Olive Downs Coking Coal Project

Additional Information to the
Environmental Impact Statement

Section 8

**Matters of National
Environmental Significance
– Wetlands**

Figure 8-1 Conveyor Corridor Options

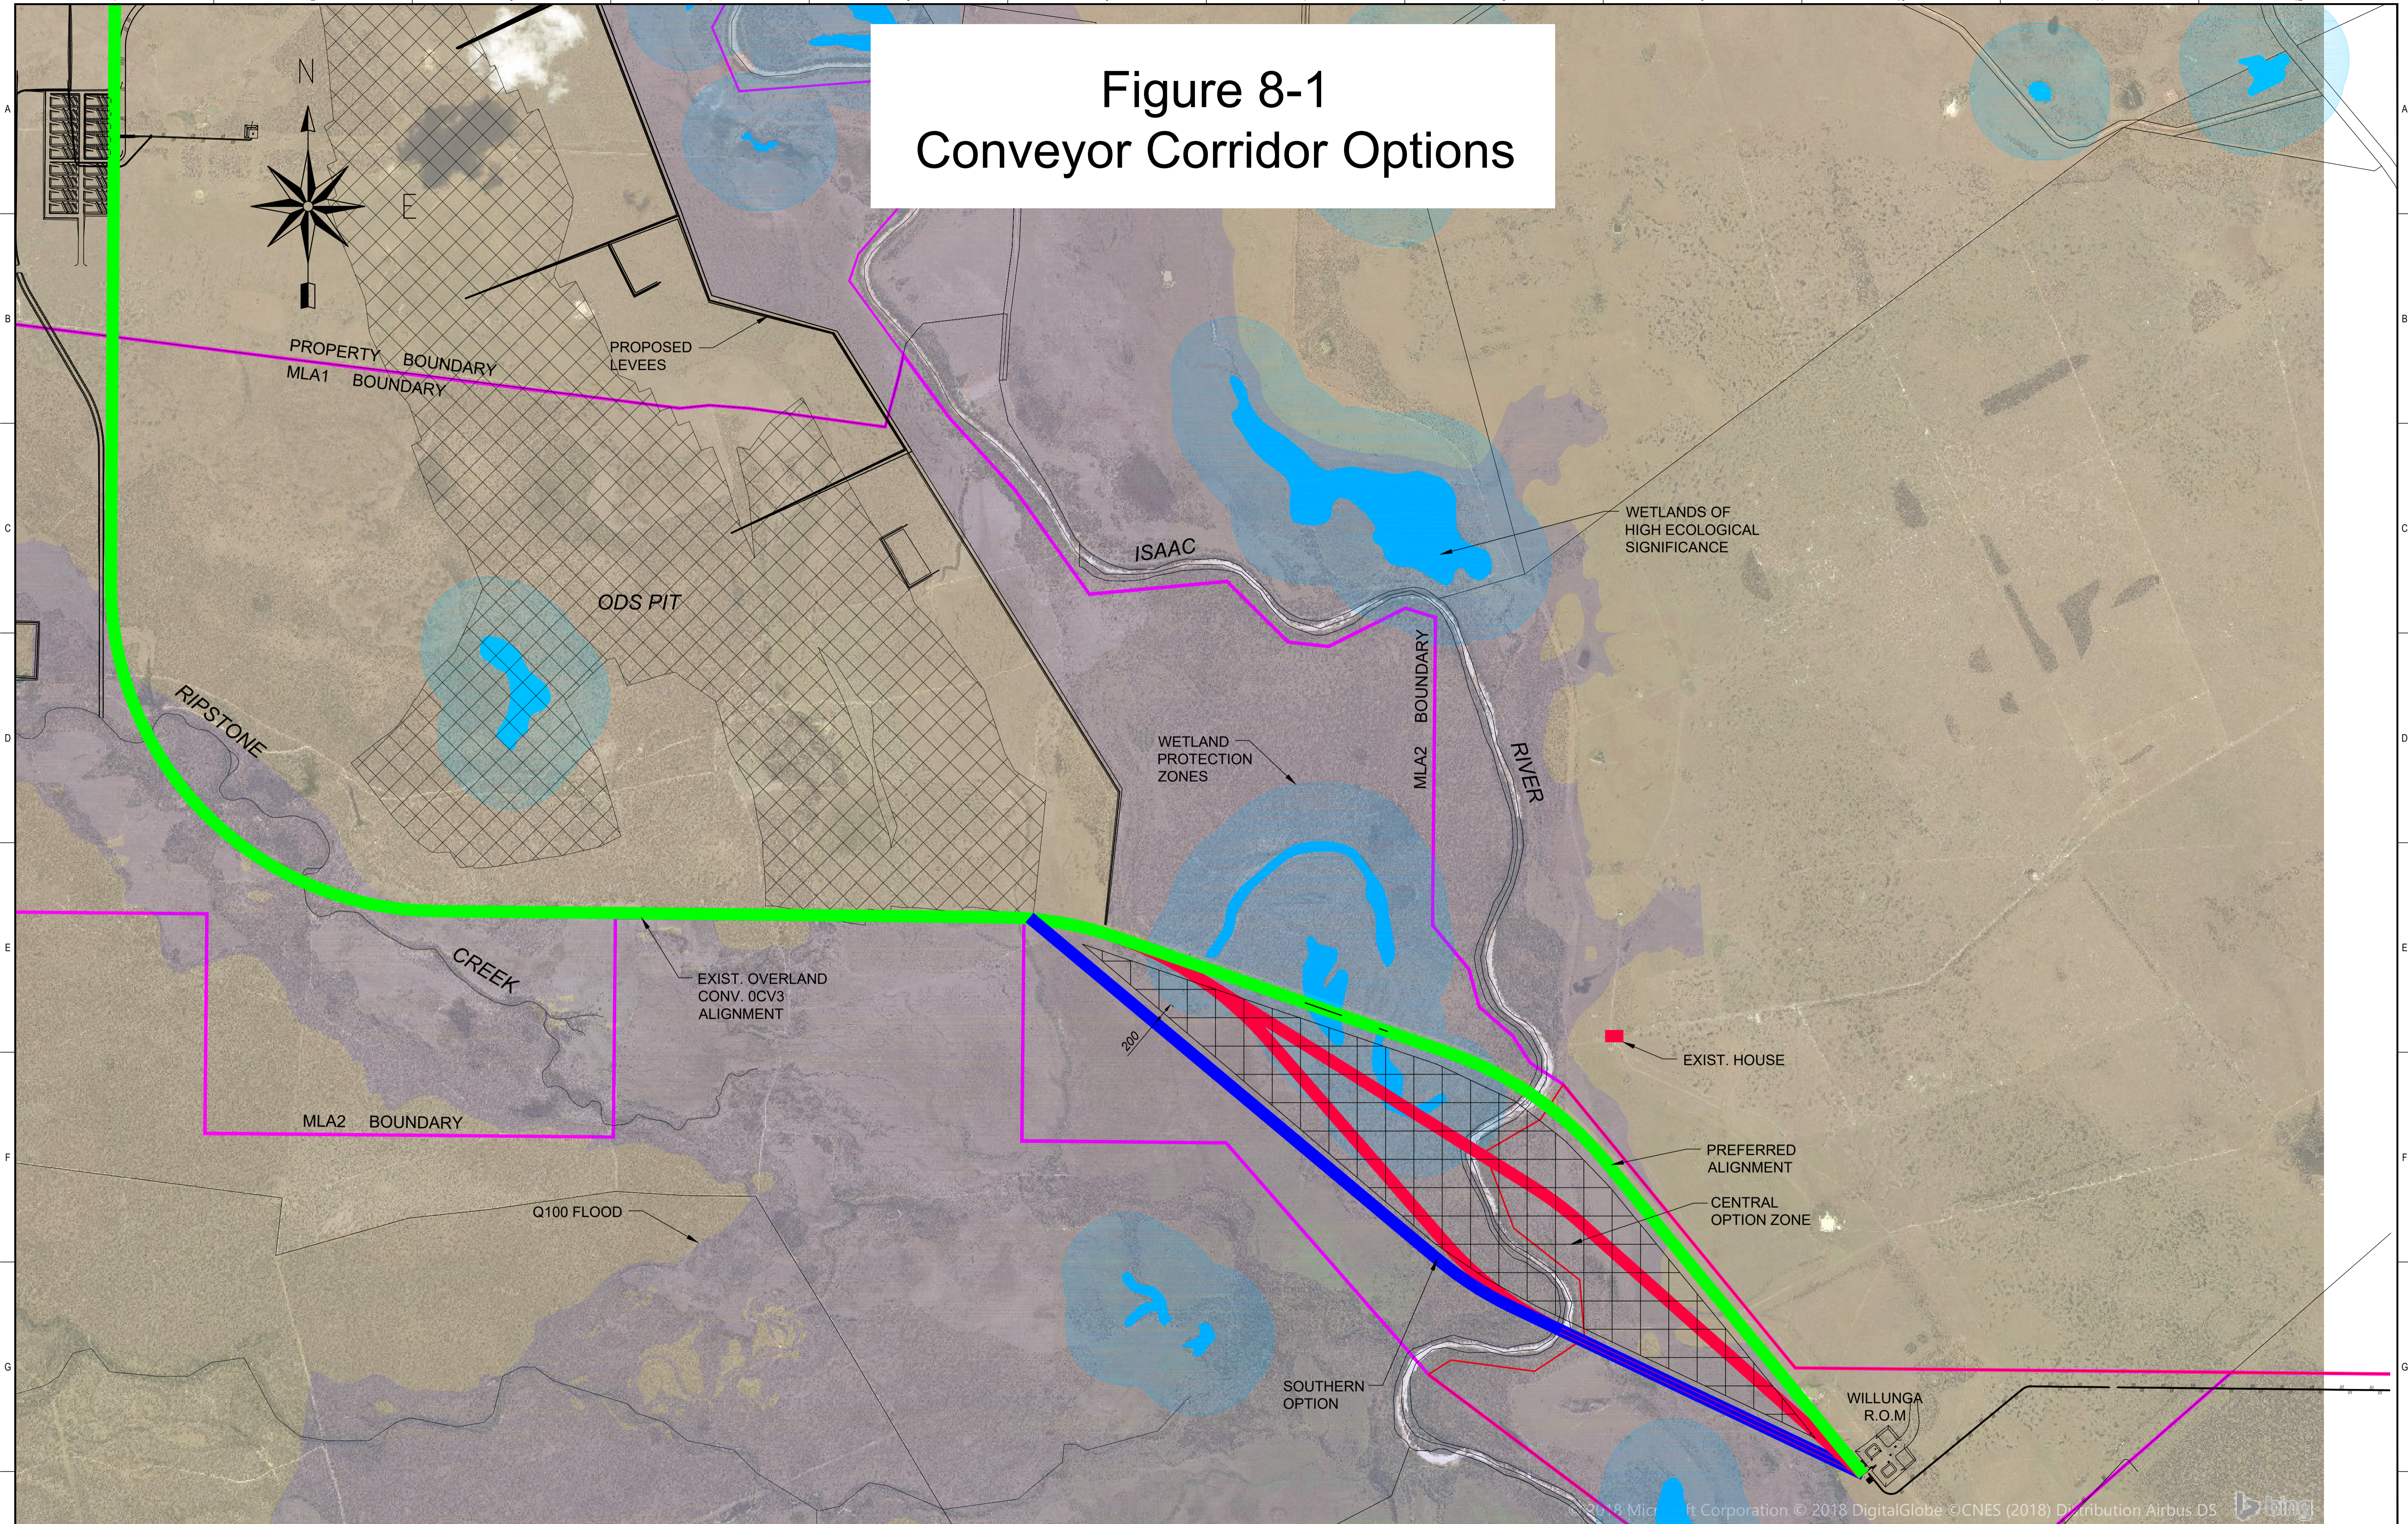
2. Specifically provide more detail on how siting of the conveyor and haul road has avoided impacts on the wetland protection areas.

Subsequent to the pre-feasibility study a further more detailed conveyor options study was undertaken for the Project feasibility study. Figure 8-1 below shows alignment options considered for the overland conveyor during the feasibility stage. The preferred alignment is shown in green, with other alternatives shown in red and blue.

Alignment options within the Central Zone shown on Figure 8-1 were also not considered to be feasible due to:

- a longer length of conveyor traversing land subject to inundation, compared to the preferred alignment, which would increase construction costs to elevate the conveyor; and
- Isaac River crossing locations not being as suitable as the preferred alignment crossing locations, requiring a higher construction cost and more disturbance of the riparian zone.

The Southern Option alignment shown on Figure 8-1 was not preferred due to:

- the alignment having to cross the longest length of land subject to inundation, resulting in the highest construction cost of all options; and
- requirements for construction of costly transfer stations which would have also increased the disturbance footprint of the infrastructure.

The alignment presented in the draft EIS (shown as the green alignment on Figure 8-1) was selected as the preferred option as it:

- maintains a more direct route than the other options which avoids the requirement for transfer stations;
- minimises the length of the conveyor and access road within land subject to inundation allowing a longer portion of the conveyor to be constructed closer to ground level and minimising the exposure of the conveyor to flood flows; and
- crosses the Isaac River at a perpendicular angle, resulting in a shorter span distance and therefore less disturbance to the riparian vegetation and river banks.

To minimise impacts of the conveyor on wetland areas, Pembroke has refined the design to include longer conveyor spans through the wetlands thereby reducing the required number of supporting trestles, hence reducing the area of disturbance in the wetlands.
